MEMORANDUM

SUBJECT: Consider Approval of a Proposed Medical Office Building, Northwest Corner of Hazelwood Street North and Beam Avenue East

Environmental Review

Project: Hazelwood Medical Office Building

LANDSCAPE PLAN
L1-1

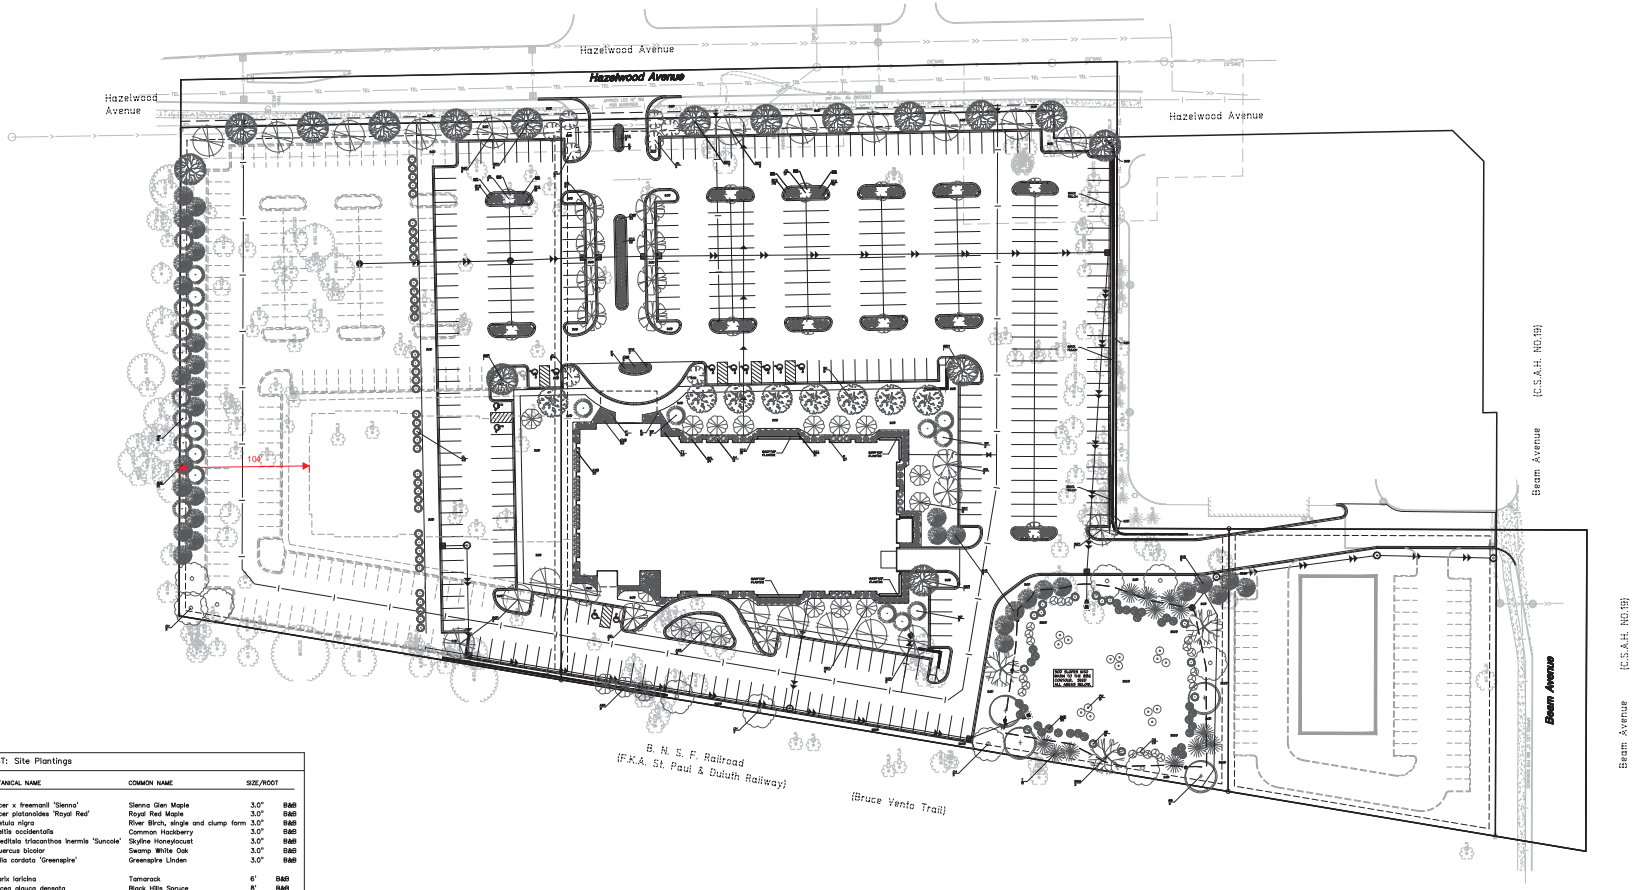
This parcel is currently vacant and holds 51 significant trees. The applicant is proposing to remove all but one of the site's significant trees. The city's tree preservation ordinance is in affect for this site and development. The residents to the north have expressed concern about the loss of the trees and other natural screening.

City ordinance requires a landscaped, and possibly screened area, of not less than 20 feet when a nonresidential use abuts a residentially zoned property. Parking lots are also required to be setback 20 feet from shared residential property lines. A petition was signed by 110 residents of Cardinal Pointe and submitted to the city asking for a green space of at least 50 yards – 150 feet – between the new medical office building at its property line. A 150-foot green space requirement would equate to approximately 1.4 acres or 16 percent of the 9.13 acre site. The Cardinal Pointe building is currently setback approximately 68 feet from the south property line. Cardinal Pointe residents currently use the area south of their building for a bocce ball court and other social activities.

In response to the neighborhood concerns and to work towards meeting the tree preservation requirements, the applicant submitted an updated landscape plan showing 33, 8-foot-tall pine and spruce trees along the shared Cardinal Pointe property line. The proposed trees should provide adequate screening between the two parcels. The project's first phase will have a building setback of almost 280 feet from the property line to the north and the trees will be planted as part of this first phase to allow additional maturation of the trees prior to phase two. In addition, when the medical office project is built out there will be approximately 88 feet between the Cardinal Pointe building and the parking lot and 172 feet between buildings.

Tree Removal and Required Replacement: The tree plan shows 51 significant trees, 853 inches in diameter. The applicant proposes to remove 50 significant trees, 832 inches in diameter. The required tree replacement is 967.7 caliper inches.

The landscape plan shows 187 new trees, 497 caliper inches. This is 470.7 caliper inches, or 235 trees, short of the requirement. It is clear that 235 additional trees will not fit on the property.

In order to comply with the City's tree preservation ordinance, the applicant must:

1. Submit a revised landscape plan that shows the following additional trees, larger trees, or mulched beds of native or drought tolerant shrubs to increase the number of replacement trees.

2. If the applicant is still unable to meet the tree replacement requirements through additional trees, larger trees, or shrubs, they may pay into the City's tree fund as outlined in the City's tree standards.
